Sandia National Laboratories

Also enclosed are revised, written comments based on SNLA reviews of the BWIP Exploratory Shaft Test Plan Document (draft, SD-BWI-TP-007). Preliminary comments were sent to Dr. Nataraja prior to the workshop meetings. Mr. Mark Board (SAI) and I reviewed the document from somewhat different perspectives as reflected in our comments. Mr. Board has a background in in-situ testing, whereas my review emphasized the various analytical aspects of the geomechanics and thermomechanics issues.

**Trip Report: A. NRC/Consultants Pre-Workshop Meeting:
held November 28, 1983, at Seattle, Washington.
B. BWIP/NRC Workshop on Underground Test
Plan: held November 29 - December 2, 1983, at
Richland, Washington.**

SNLA REVIEW of BWIP'S DRAFT EXPLORATORY SHAFT
TEST PLAN - REVIEW SET B

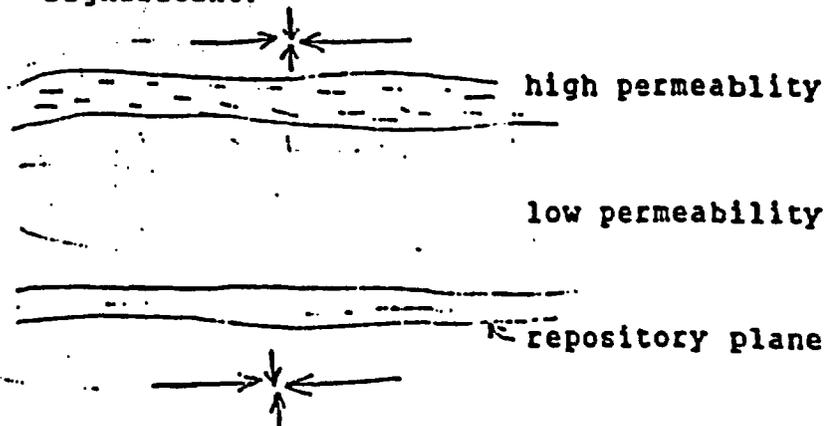
- cannot always tell one flow from the next merely by physical inspection, but must rely on the geophysical signature.
- 4-5 Poor statement of justification. Should simply state that actual site-specific measurements of fracture properties are necessary for modeling and design. Quality of data has nothing to do with it. Instead of tectonic features it should be straightforward and say faulting, etc. This is confusing as folding is also tectonic. Please define tectonic feature, i.e., is a blowout structure considered tectonic? Is high horizontal stress considered a tectonic feature, etc.?
